UNITED STATES PATENT AND TRADEMARK OFFICE

10/715,164

| Office Action Summary | Application No. 10/715,164 | Applicant(s) WATSON, RICHARD | |

DETAILED ACTION

Fig. 4

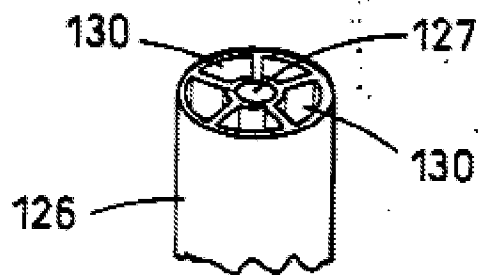
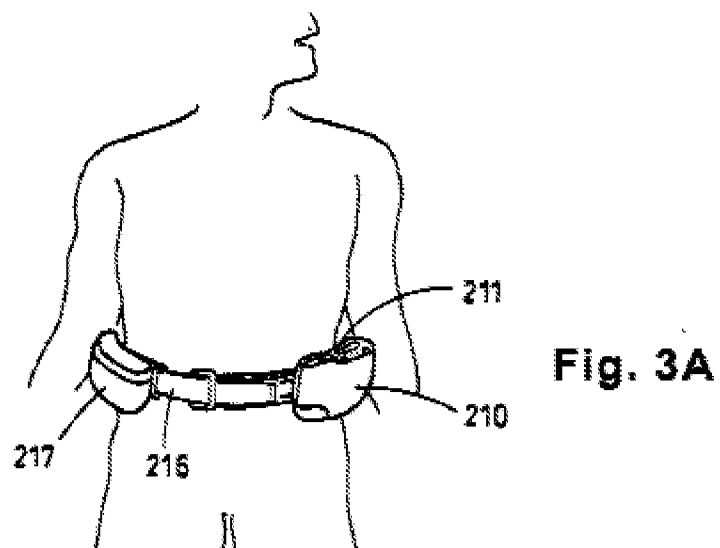
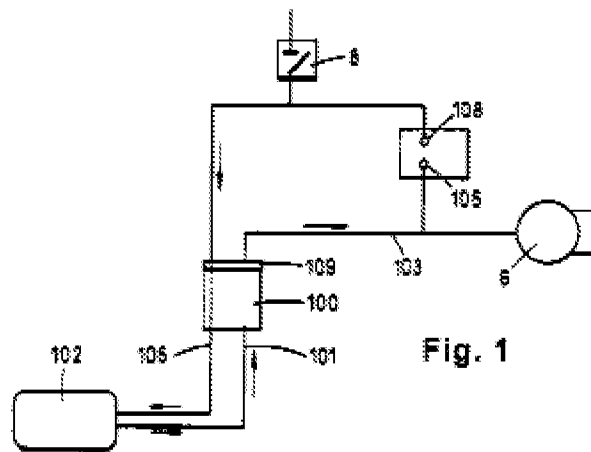
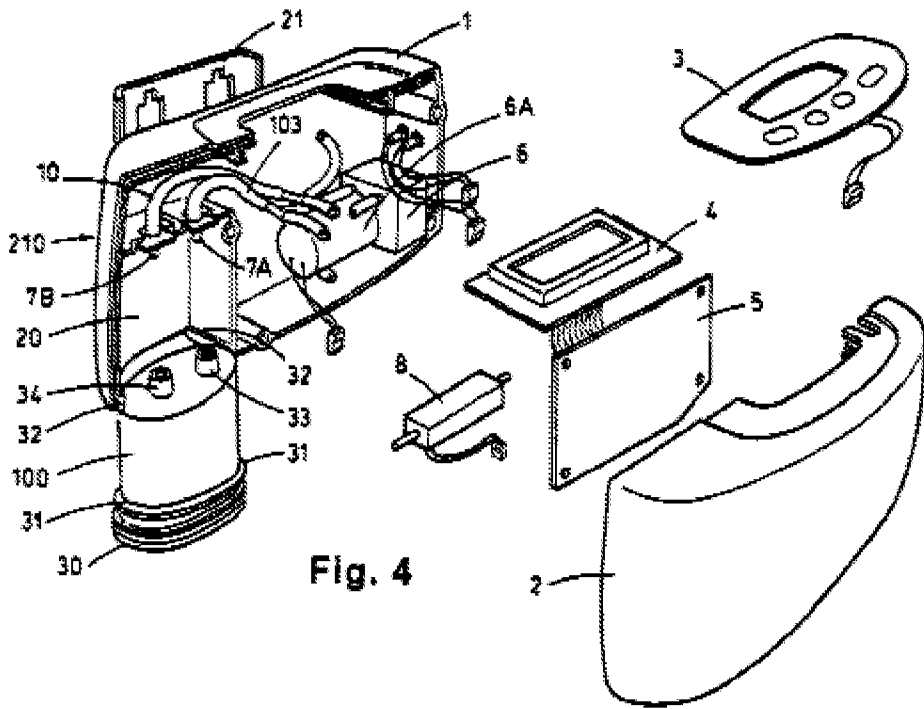
Regarding claims 21, 41 and 48, Hunt teaches a personally portable vacuum desiccator (210) for collecting and storing liquid exudate comprising:

a removable cartridge (100) having an interior chamber, a perforated (127, 130, 606,607) gas flow channel (126), an inlet and outlet ports (32, 33);

a vacuum pump member (6) in gas/liquid communication (103) with the outlet port (33) of the chamber;

a motor (6A) operably connected to said vacuum pump (6); and

a tube (106) having a first end in fluid communication the inlet port (32)(100)(see figures 1, 3A, 4, 5F and 6E, *infra*).

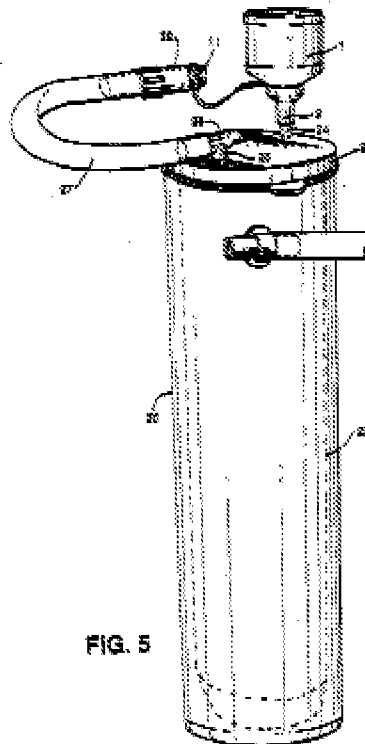
Regarding the perforated gas flow chamber, see figures 5F and 6E, supra. Perforated is interpreted herein as meaning something with holes in it. perforated. (2008). See *Merriam-Webster Online Dictionary*. Retrieved October 14, 2008, from <http://www.merriam-webster.com/dictionary/perforated>.

8. Applicants assert that neither Hunt, Mahar, Alecoa nor Ohira teach or suggest a perforated gas flow channel. This argument is not persuasive because Hunt discloses a perforated gas flow chamber (126)(see the detailed rejection supra and figures 5F & 6E). The claims must be given their broadest reasonable interpretation. MPEP § 2111. A dictionary definition of "perforated" includes something with holes in it. See *Merriam-Webster Online Dictionary*. Retrieved October 14, 2008, from <http://www.merriam-webster.com/dictionary/perforated>. Hunt's tube (126) has longitudinally extending holes that are capable of permitting gas flow therethrough. Applicants' specification does not provide a specific definition that precludes this interpretation of "perforated."

FIG. 1

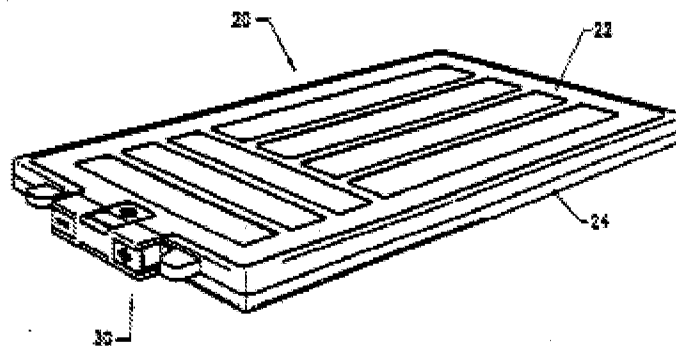
Aldecoa teaches a slim planar battery (20) that is shaped for insertion into compact personal electronic devices (abstract)(see fig. 1, infra).

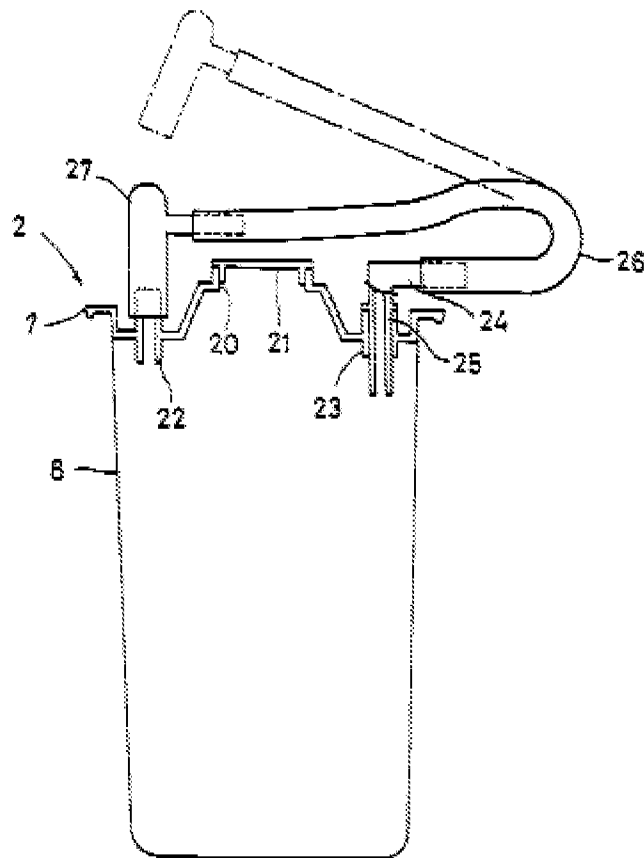
Maier teaches a bodily fluid collect receptacle (20) to which an absorbent gelling treatment is added to the interior thereof to solidify liquid exudates. This avoids hazards associated with spillage (abstract)(see fig. 5, infra).

Ohira teaches a one-way check valve in entrance port (22). This prevents unwanted reverse flow of liquid out of the container (col. 13, lines 42-49)(see fig. 2, infra).

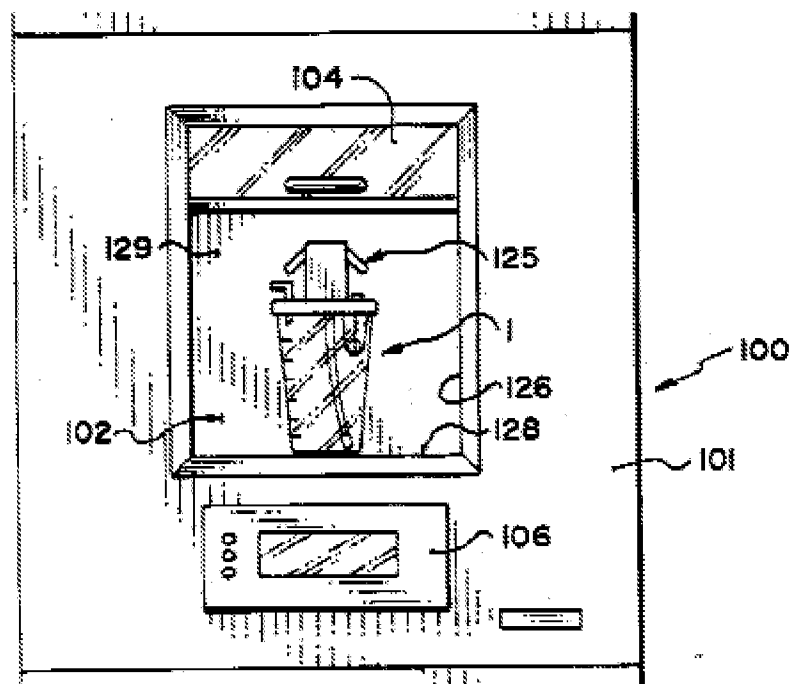
Hunt, Maher, Aldecoa and Walker fail to claim a limitation where the chamber is transparent. Walker teaches that it is known in the art to use transparent canisters (1) for containing such material in order to visually inspect its content without opening the device (see fig. 2, infra).
